**Item No. 9 Local Improvement Projects to be funded and constructed in 2006 - Construction of a Granular Lane at the Rear of 130 and 132 King's Drive**
**File SL(2006)**

**RE: Local Improvement Projects to be Funded and Constructed in 2006 – Construction of a Granular Lane at the Rear of 130 and 132 King's Drive**

**REPORT DATE:** November 7, 2006

# APPENDIX "B"

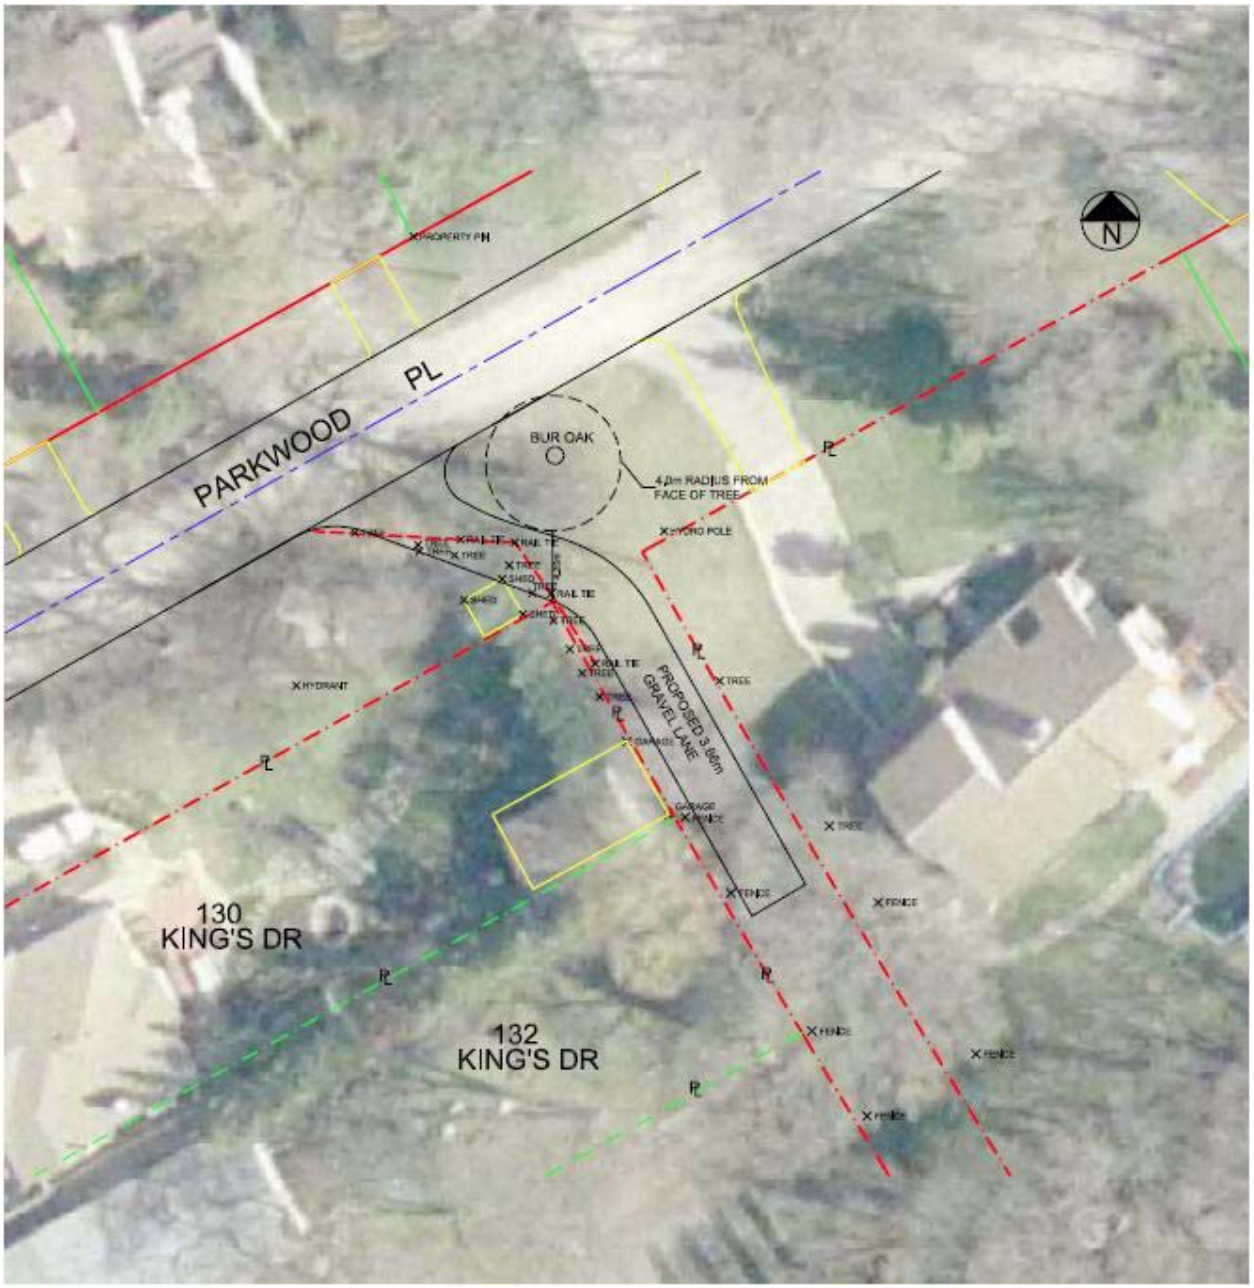
*Advantages:*

- The revised lane proposal has little impact on the existing trees within the lane right-of-way.
- The lane provides access to 130 and 132 King's Drive.

*Disadvantages:*

- The proposed alignment, with a four (4) metre buffer around the existing bur oak tree at Parkwood Place, requires that the owner of 130 King's Drive remove a shed and approximately six (6) mature spruce trees that he has planted within the Parkwood Place right-of-way.

- The elimination of the turn around at the south end of the proposed lane will make it more difficult for the Streets Maintenance Division to provide snow clearing operations and will require that motorists who mistakenly enter the lane to back out.

- The revised lane alignment will have a bend introduced to allow for the 4m buffer, this will make winter navigation of the lane more difficult.
- The shorter limit does not allow for access to 136 King's Drive.

- The Community Committee requirement that the project proponent to remove his front approach will increase the vehicular use of the lane which may not be desired by the residents in opposition.

- The owner of 572 Parkwood Place has identified to Public Works staff that he opposes any lane installation at this location.

| PROPOSED GRANULAR SURFACE LANE (GRAVEL)<br>ON THE FIRST NORTH-SOUTH LANE EAST OF KING'S DRIVE<br>FROM PARKWOOD PLACE TO A POINT APPROXIMATELY 193 FEET SOUTH OF PARKWOOD PLACE | | Drawn By: cwh<br>Drawing: King's Drive<br>Date: Dec. 5, 2005 |

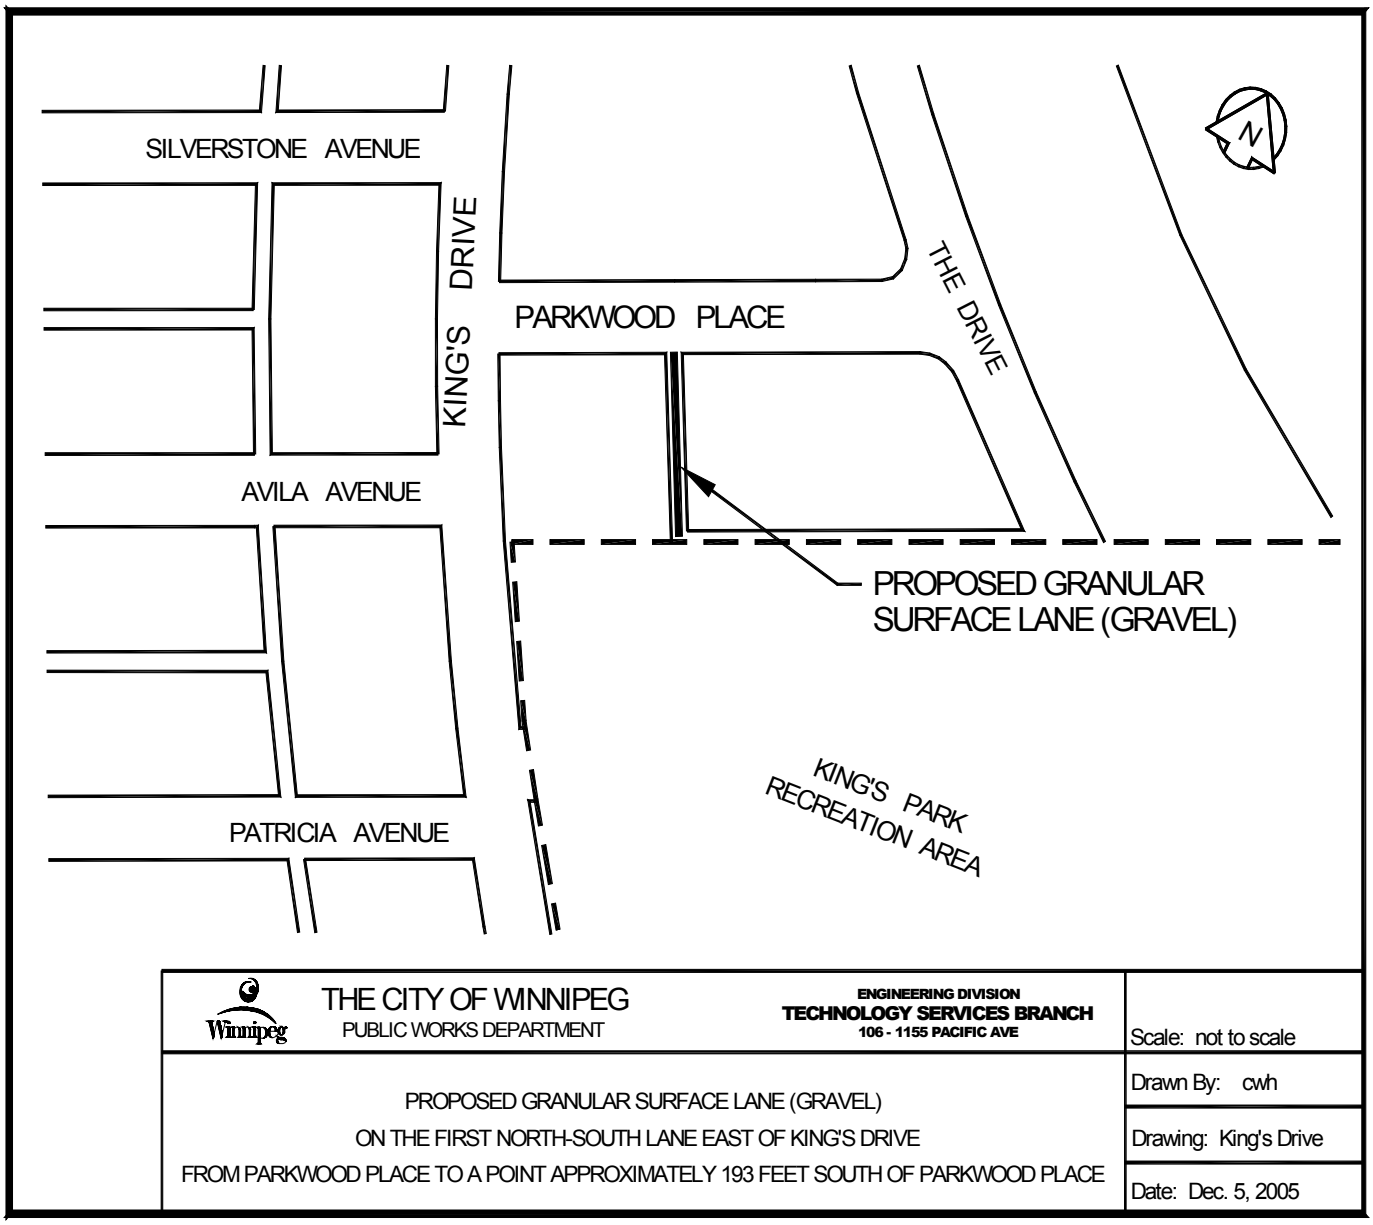
With reference to the local improvement application Work Order No. 1220240106 for the installation of a gravel lane at the rear of 130, 132, 136 Kings Drive, the Public Works Department has circulated the proposed plan for the installation of a lane at this location and has received comments back.
Based on the information provided, the Public Works Department **recommends against the approval of this project.**

The Urban Forestry Branch of Public Works has inspected the proposed site and noted the installation of a granular surface lane at the rear of numbers 130, 132 and 136 King's Drive will require the removal of numerous trees and/or the removal of the root systems.

The Urban Forestry Branch has noted the planned use of heavy equipment to excavate and remove the excess earth, place grade and compact the granular material would damage the tree root system. The roots of an oak are considered to extend underground to a radius equal to or greater than the height of the tree. Most of the roots (90%) for an oak are located within 30 centimetres of the ground surface. The roots of the oak are susceptible to compaction, the "squeezing out" of moisture, from the weight of both the gravel and vehicles.

An existing 79cm diameter oak tree is in direct alignment with the east edge of the proposed lane. Public Works has considered relocating the proposed lane to the furthest point possible, west of the tree; however, this realignment will not reduce any potential damage to the tree roots.

Proposed Lane Plan - 132 King's Drive

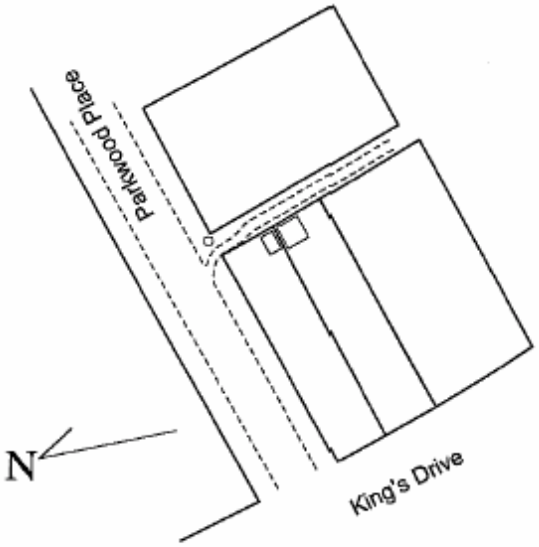
1. Moving the centre line of the lane west for the first 20 metres.
2. Having the entrance to the lane off the right-away of Parkwood (see illustration on page 3). Traffic will be entering the lane traveling east, and exiting west which allows for the access to curve, allowing a wider berth around the tree.
3. Using crushed, washed gravel instead of limestone to prevent leaching and to mitigate pH concerns.
4. Using a small loader such as a Posi-Track All Surface Loader (exerts only 2.5 psi ground pressure) to construct the lane to prevent damage to root systems that could occur by large equipment.
5. Allowing the gravel to compact slowly with the residential traffic (which will be minimal as it only will service three properties).
6. Using an alternative surface such as Turfstone or bridging to prevent loading of the tree roots.

1. Constructing a lane of only 130' to eliminate the t-intersection/hammerhead. This would end the lane at the southeast corner of 132 King's Drive which is prior to the Spruce trees at the rear side lot line of 572 Parkwood Place. This also eliminates the need for the installation of a drainage culvert to the Parkwood Place south side ditch. Therefore eliminating the need to trench through the oak and ash tree roots.

2. Narrowing the lane for the first 20 metres south off Parkwood Place to allow for maximum buffer zone around the Bur Oak.
